Nassau County Solid Waste Department
West Nassau Landfill - Final Closure
Contract No. CM1734 (Bid No. NC11-004)

ALLOWANCE AUTHORIZATION
(Line Item #4)

Allowance Authorization No.: 06

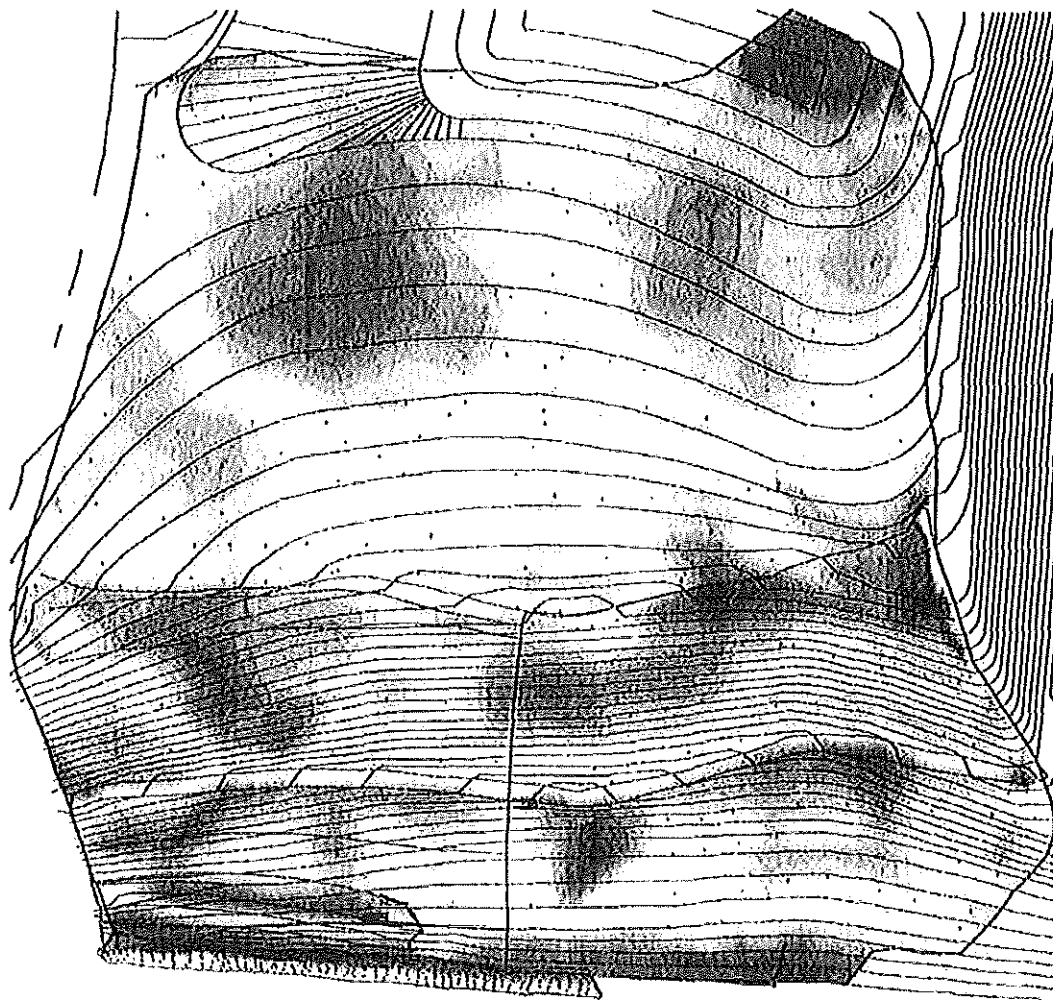
Please find the attached data collected for the southwest corner of the south slope area re-worked. This area includes removal of leveling layer and waste, and then the replacement of the leveling layer. The area generated a cut total of 1,325 c.y. @ \$2.75/c.y. = \$3,643.75, and the leveling layer generated a fill of 635 c.y @ \$9.50/c.y. = \$6,032.50. The total for this work \$9,676.25. We have not completed the measurement of liner used to complete the tie-in repair as required for the southwest corner into the existing closure yet. This will likely be included with the liner tie-in as built quantities. I will send this to you separately once they can measure. We will include Shawn in this area as he can verify for Golder and Nassau County. I will have Thomas Raab prepare the allowance request for the quantities listed above.

1	Additional labor, materials and equipment for the cuts and fills required to field fit the grading for the liner tie-in at the southwest corner of the closure construction limits as described in the email with backup dated 12/21/11 (Attached).	\$ <u>9,676.25</u>
---	---	--------------------
